# Access Compliance Report

## Public Rights-of-Way

### (Curb Ramps)

Intersection ID: 15398	Main Street: COLVILLE_RD	Cross Street: HEMPSTEAD_PL	Location: SW
ADA ID: 3D2D68B02B87	Ramp Type: PerpDiag	Initial Pass/Fail: Fail	Overall Compliance: No
		Severity Score: 12.5

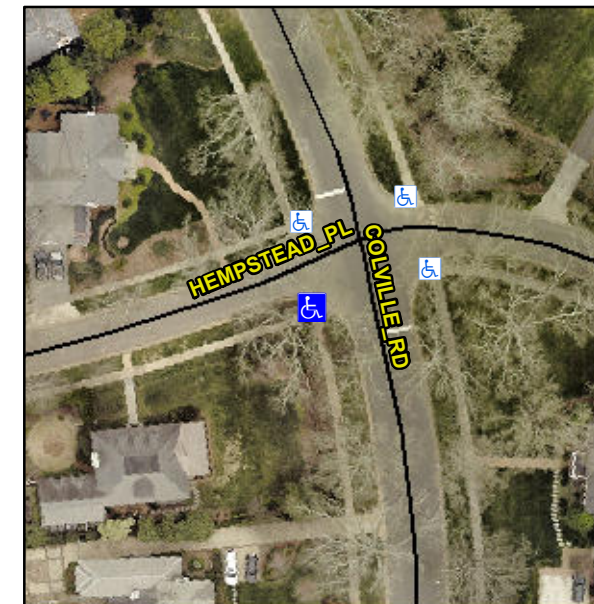
**Not Found, R304.2.2**

Compliance	Description	Data	Compliance	Description	Data
N/A	Ramp Length (in)	63.0	No	Ramp Slope (%)	10.2
Yes	Ramp Width (in)	48.0	Yes	Ramp XSlope (%)	0.2
N/A	Flare Type LT	N/A	N/A	Flare Type RT	N/A
N/A	Flare Slope LT (%)	N/A	N/A	Flare Slope RT (%)	N/A
N/A	Flare Traversable LT?	N/A	N/A	Flare Traversable RT?	N/A
N/A	Landing Length (in)	N/A	N/A	DWS Provided?	N/A
N/A	Landing Width (in)	N/A	N/A	DWS Contrast?	N/A
N/A	Landing Slope (%)	N/A	N/A	DWS Length (in)	N/A
N/A	Landing X Slope (%)	N/A	N/A	DWS Full Width?	N/A
N/A	Landing Curb? (Y/N)	N/A	N/A	DWS Offset (in)	N/A
N/A	Shared Landing?	N/A			
N/A	Gutter Ponding?	Yes	N/A	Gutter Slope (%)	N/A
N/A	Gutter Lip Ht (in)	N/A	N/A	Gutter X Slope (%)	N/A
N/A	Painted X Walk1?	No	N/A	Painted X Walk2?	No
	X Walk 1 Direction	To E		X Walk 2 Direction	To N
N/A	X Walk 1 Width (in)	N/A	N/A	X Walk 2 Width (in)	N/A
	X Walk 1 Slope (%)	1.9		X Walk 2 Slope (%)	3.8
	X Walk 1 X Slope (%)	2.9		X Walk 2 X Slope (%)	0.5

**Remove & Replace Curb Ramp With Two New Directional Ramps or Equivalent.**
